## City of Ketchum

### **Recommendation To Approve Change Order #4 to Contract 20454**

Project Description: Fire Station CM/GC

Change Order #:004

S2.01 - FOUNDATION PLAN

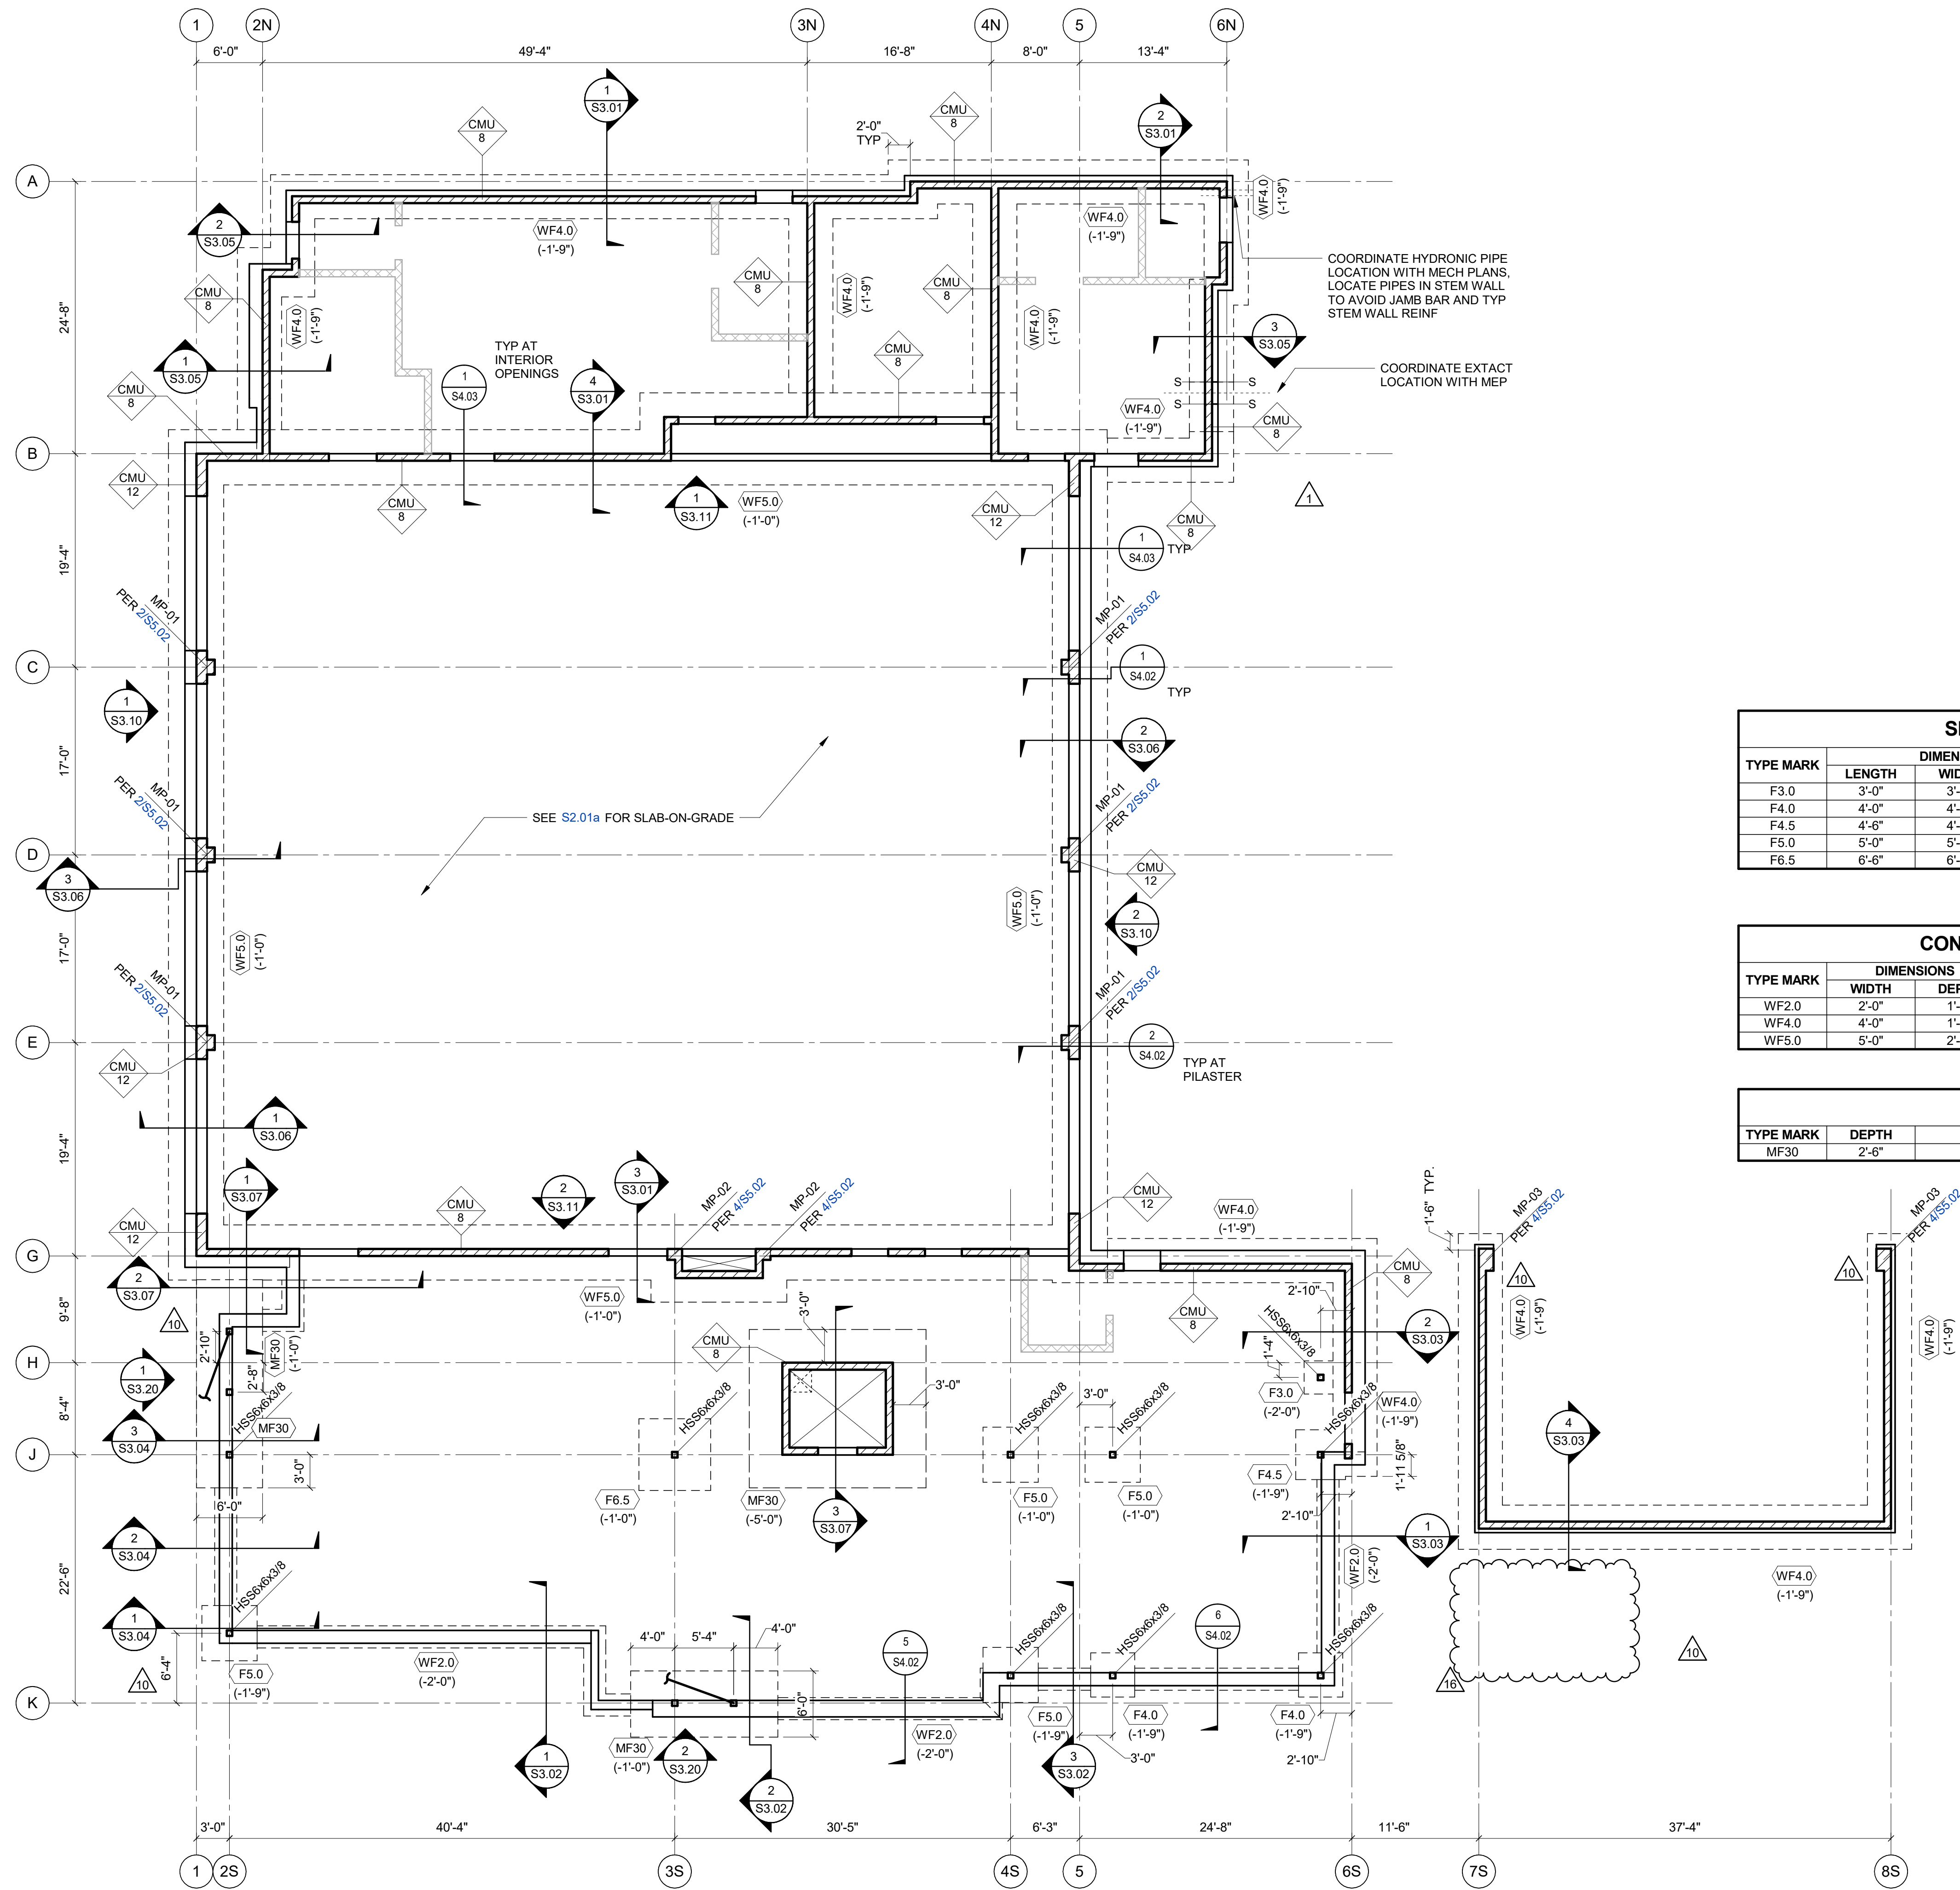
The updated design will have no columns and not conflict with the underground conduits.

1 SLAB ON GRADE PLAN  
1/8" = 1'-0"

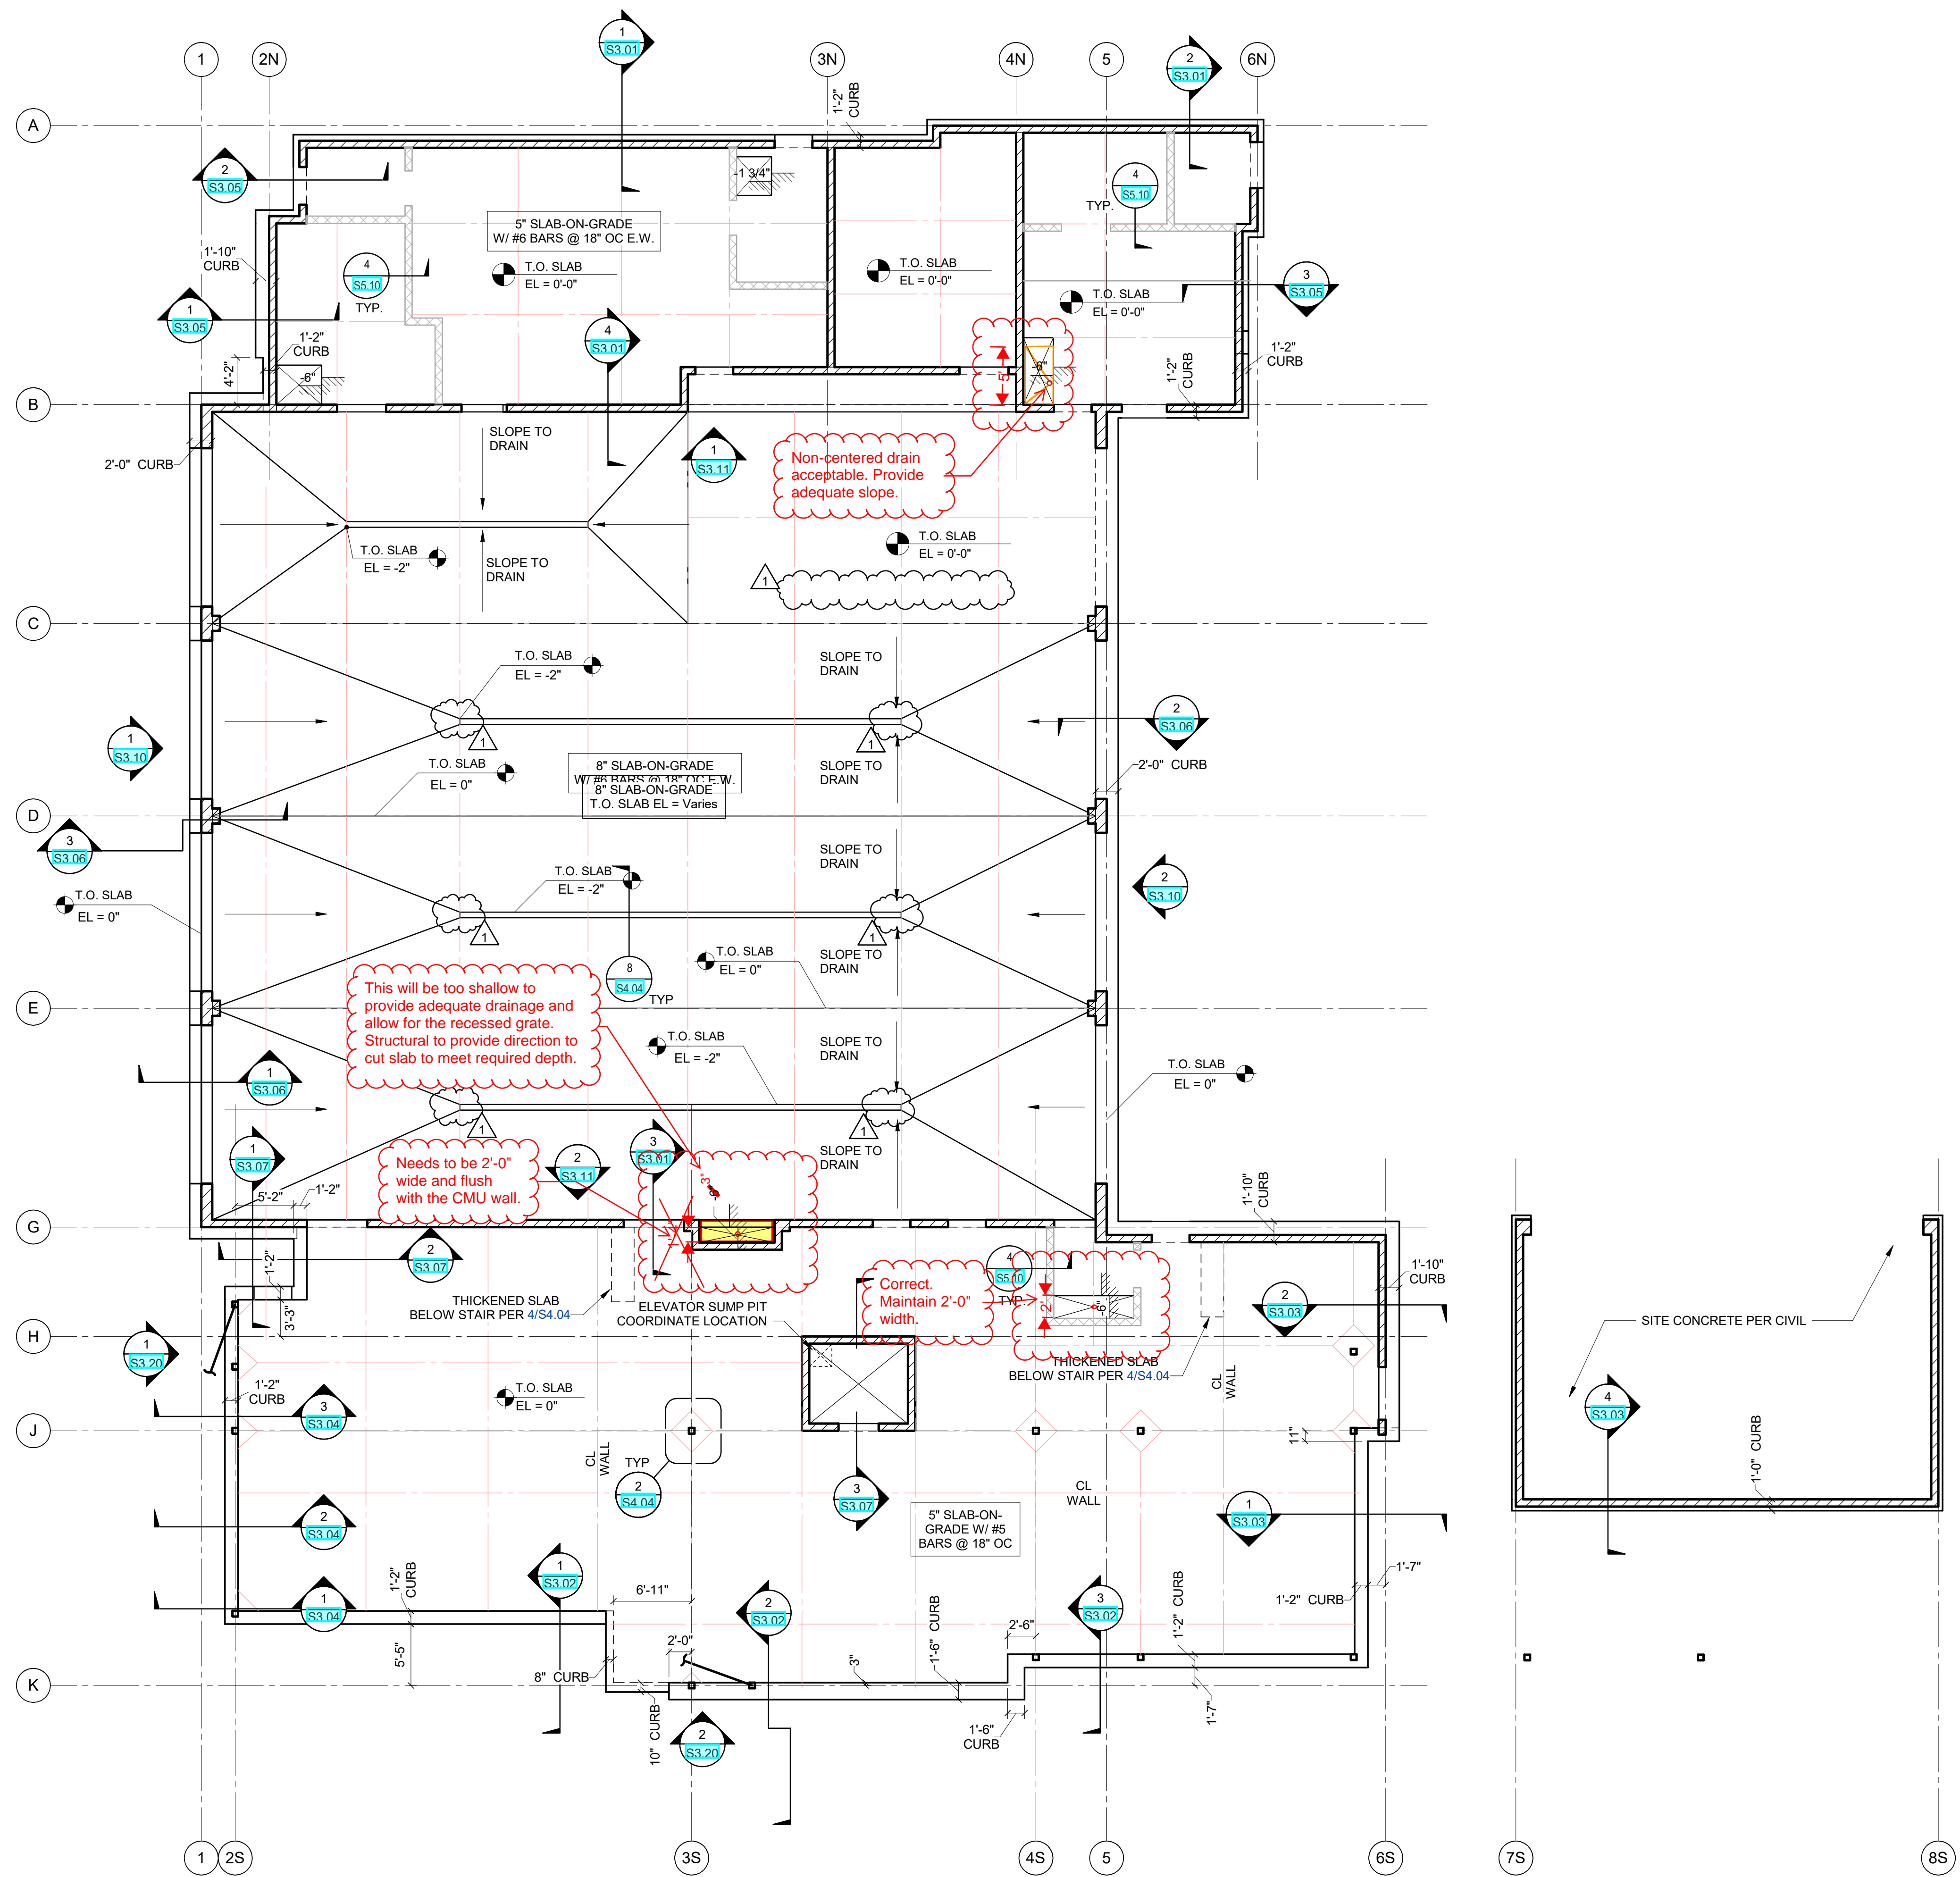
See attached marked up slab on grade plan.

- 1) Drain locations are acceptable. Maintain required slope for adequate drainage.
- 2) 3" depressed slab will be too shallow to provide adequate drainage and allow for the recessed grate. Structural to provide direction to cut slab to meet required depth.
- 3) Drain location is acceptable. Maintain required slope for adequate drainage.
- 4) Maintain 2'-0" width.

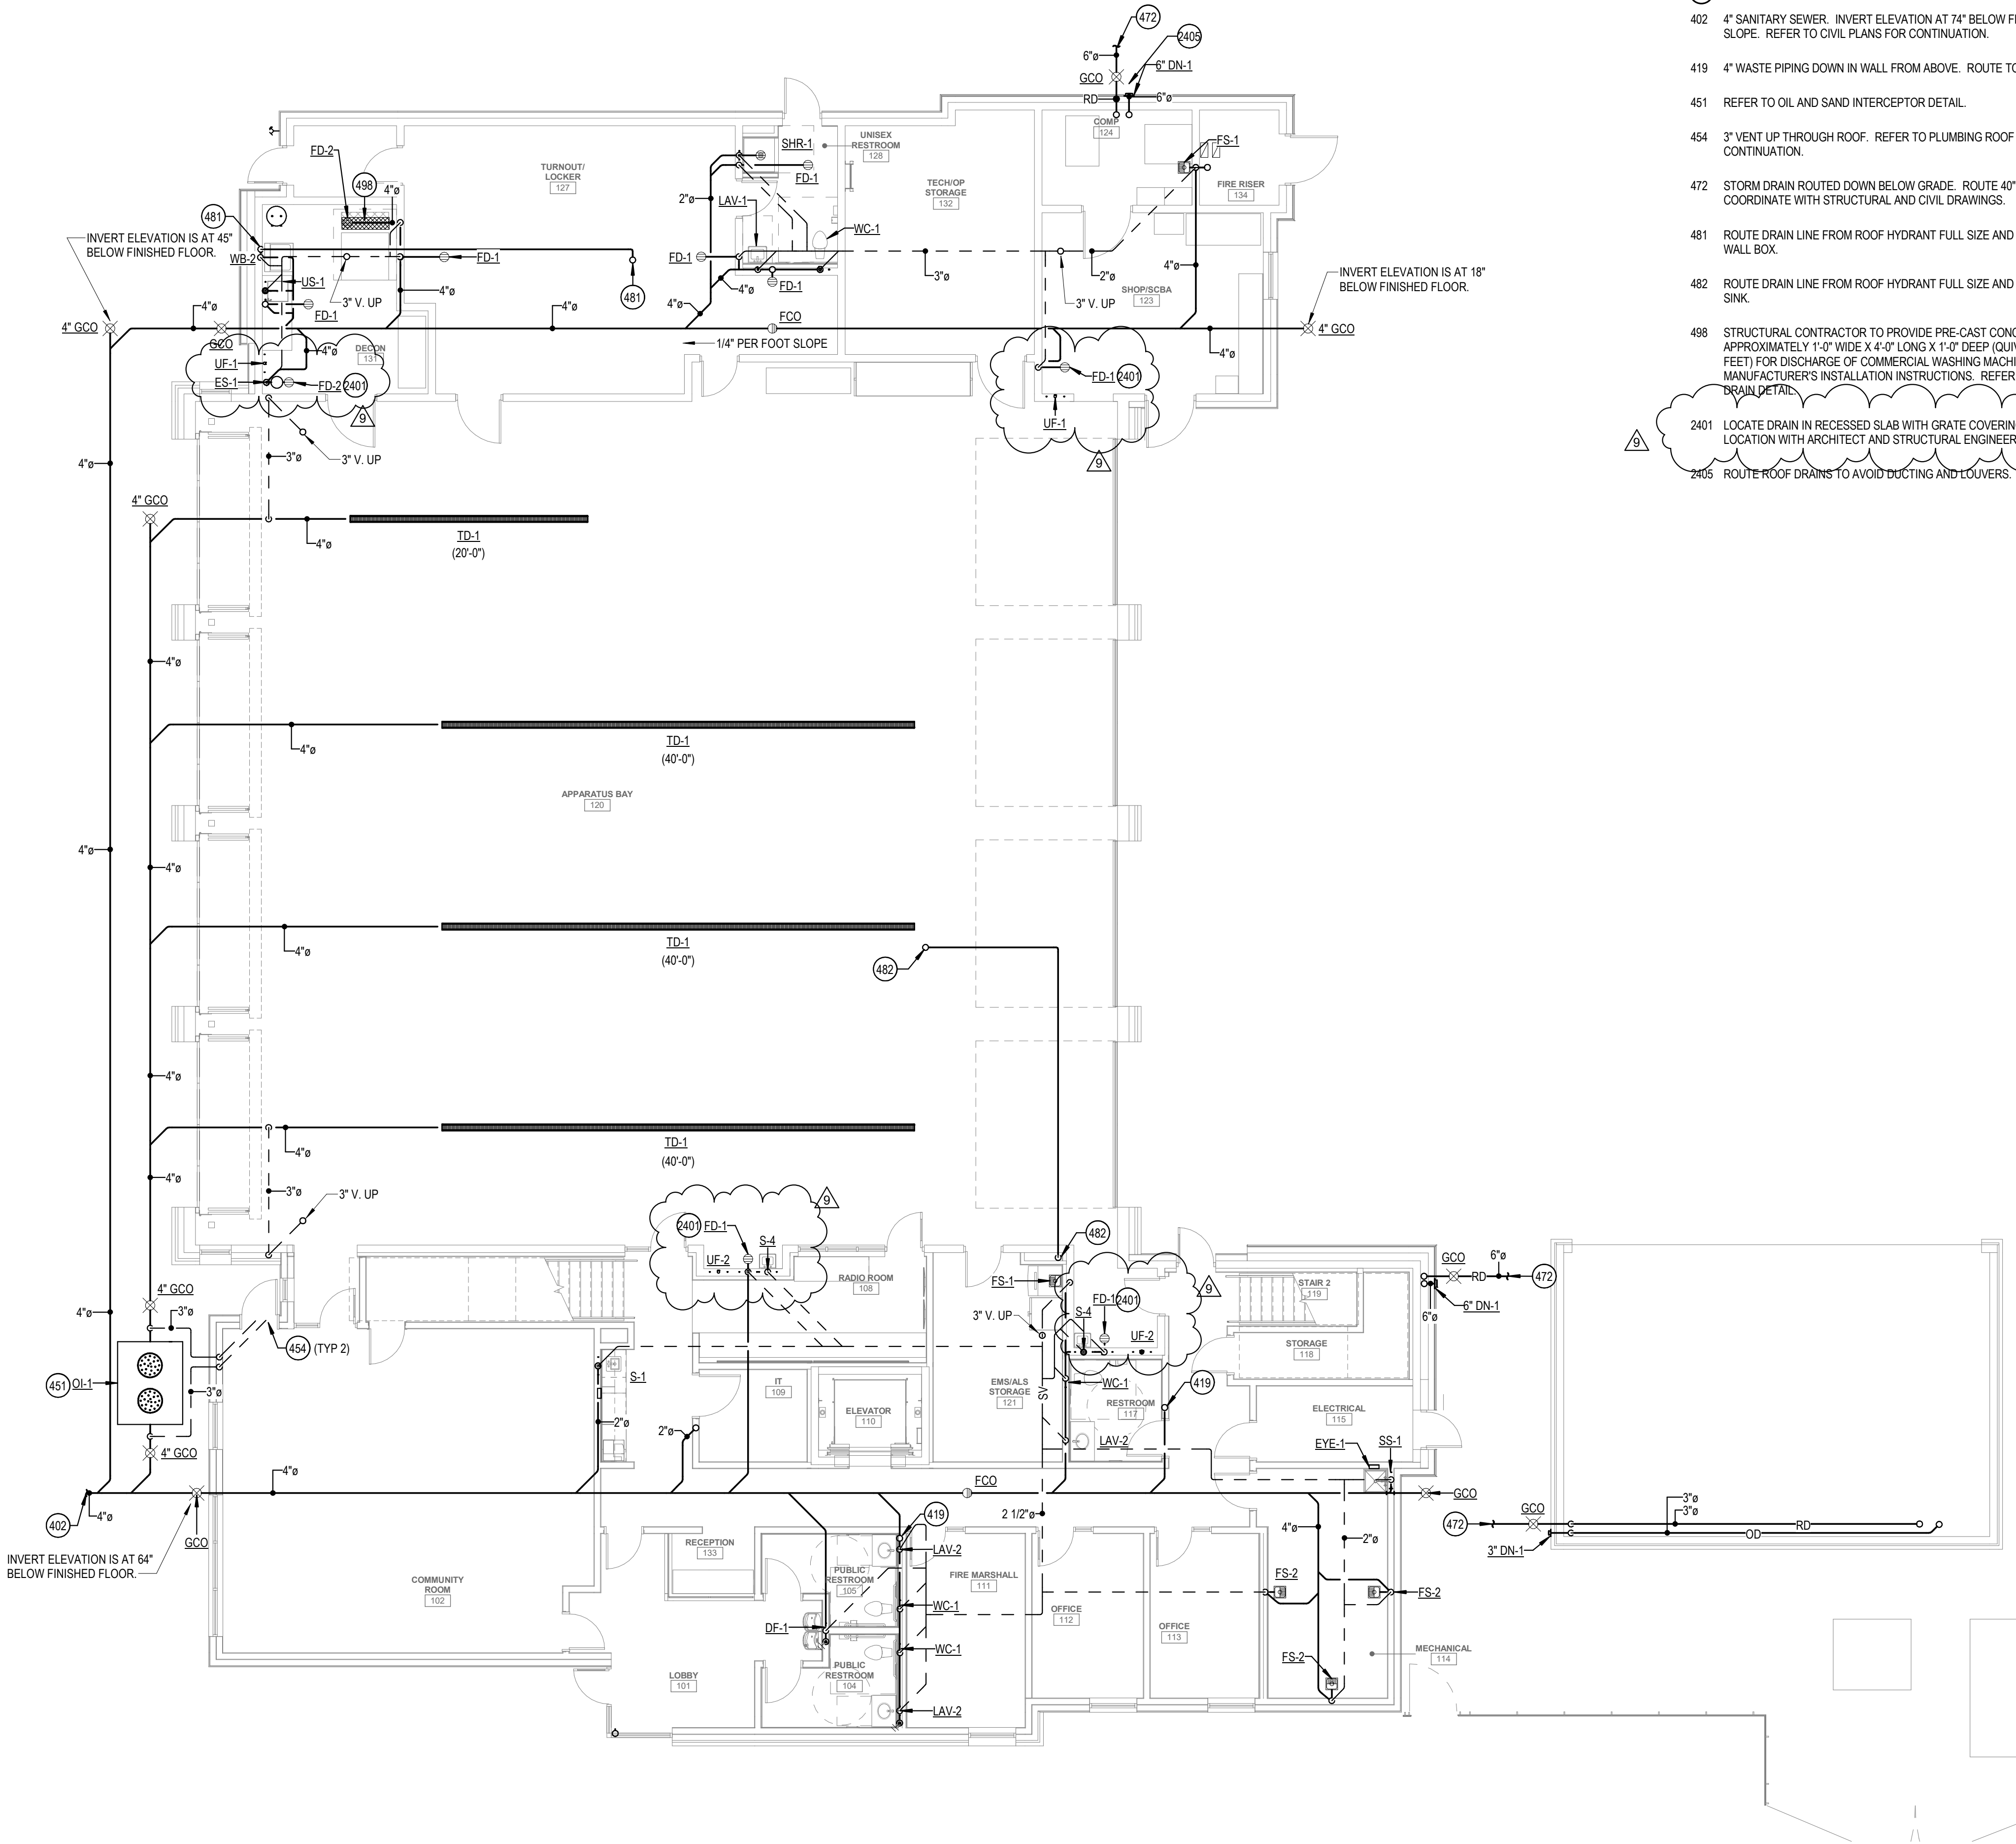
Upon further review of the plumbing drawing P2.00 issued as part of ASI-4 various items were not included in the narrative that effect the function of the plumbing system. Please confirm design intent and added scope:

Please see attached sheets P1.00, P2.00, P5.01 & P6.00 and attached narrative in response to design intent and scope. All revisions are clouded with delta 9.

- Added note 2402.
- Decon 131 added water lines, RBPB-1, UF-1, bubble 2402.
- Shop/SCBA 123 added water lines, UF-1, RBPB-1, bubble 2402.
- Boot wash area added water lines, UF-2, S-4.
- Corner of App Bay new restroom 117 added water lines, removed UF-1, added UF-2, S-4.
